**ADDENDUM NUMBER ONE**  
**RFQ # 7548596**

**TITLE: New Lifts at DMV-Testing and Emissions Center, 325 Melrose St., Prov., RI**  
**Closing Date and Time: 4/14/14 at 2:00 PM**

## *FloGard® LoPro Trench Drain Filter*

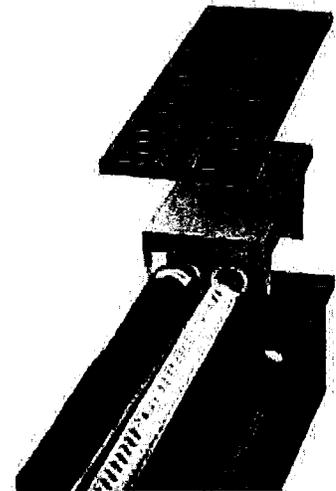
Attached is the cut sheet for the trench drain filter. Model to be used is FG-TD0F6.
